World Forum for Harmonization of Vehicle Regulations**Working Party on Passive Safety****Seventieth session**

Geneva, 6–10 December 2021

UN Regulation No. 16 (Safety-belts)**Proposal for Supplement 4 to the 08 series of amendments to
UN Regulation No. 16 (Safety-belts)****Note by the Secretariat***

"Figure 3
ISO/B3 - Envelope dimensions for booster seat, full width 520 mm - without ISOFIX, or with connectors removed or stowed within the body of the fixture (behind line E, as defined by detail B)

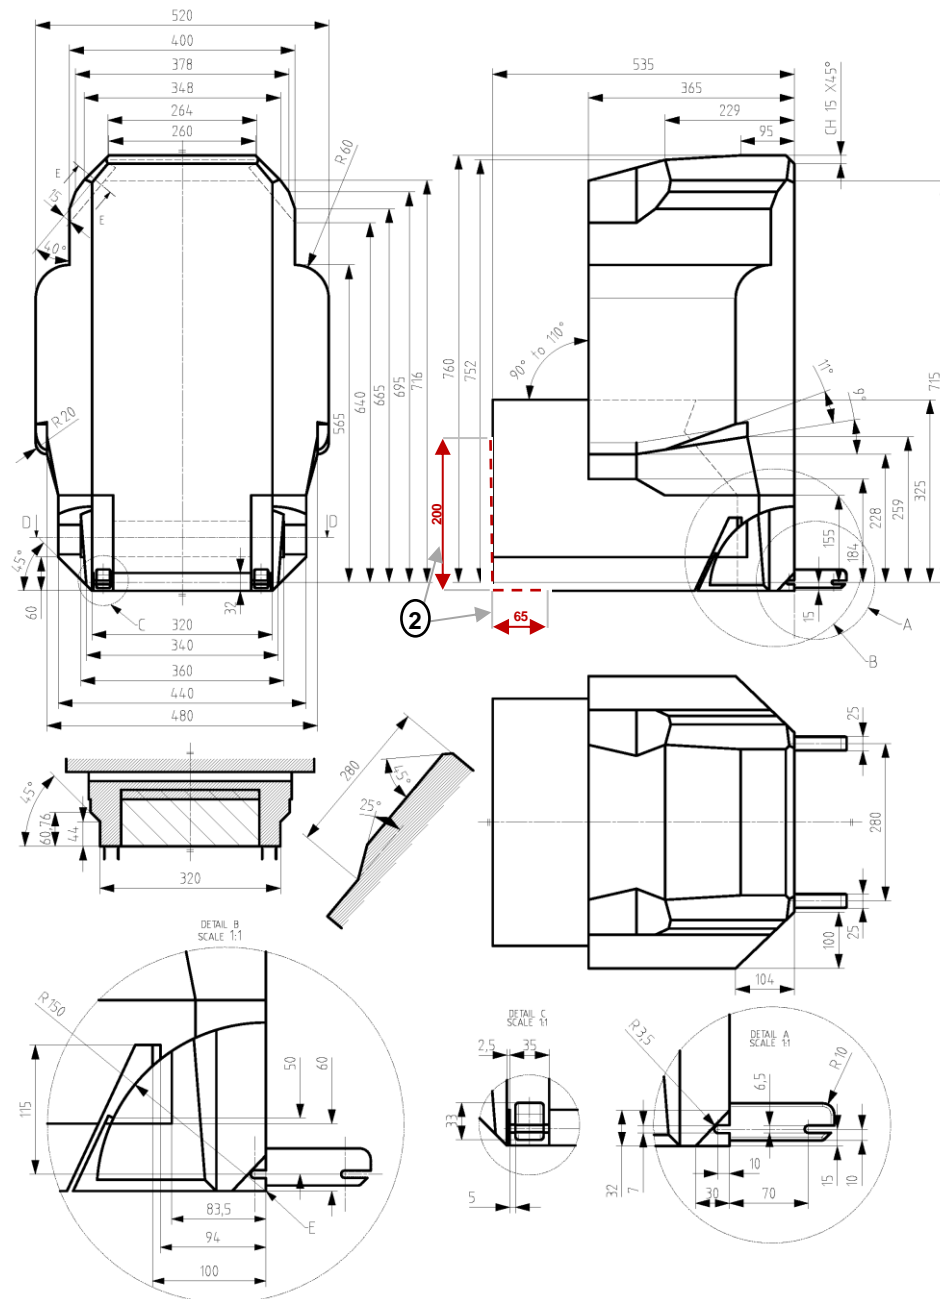
The text reproduced below was prepared by the expert from Spain to update the drawings of the child restraint booster seat volumes to allow the possibility of a support leg. The modifications to the current text of the UN Regulation are marked in bold for new or strikethrough for deleted characters.

Annex 17 – Appendix 5, Figure 3, amend to read:

1. E is the reference axle of rotation of the backrest (90° to 110°) and reference line for retraction/stowing of ISOFIX
2. Dashed lines mark the area where an anti-rotation device, or similar is allowed to protrude"

1. For non-integral ECRS which are part of a multigroup, from 76 cm to 100 cm integral, with support leg, category i-Size, and where the support leg cannot be hidden, it shall be possible to approve ECRS with the support leg installed as a specific vehicle booster seat.
 2. This modification to the booster seat envelopes would allow a support leg to protrude from the booster seat Child Restraint Fixtures
-
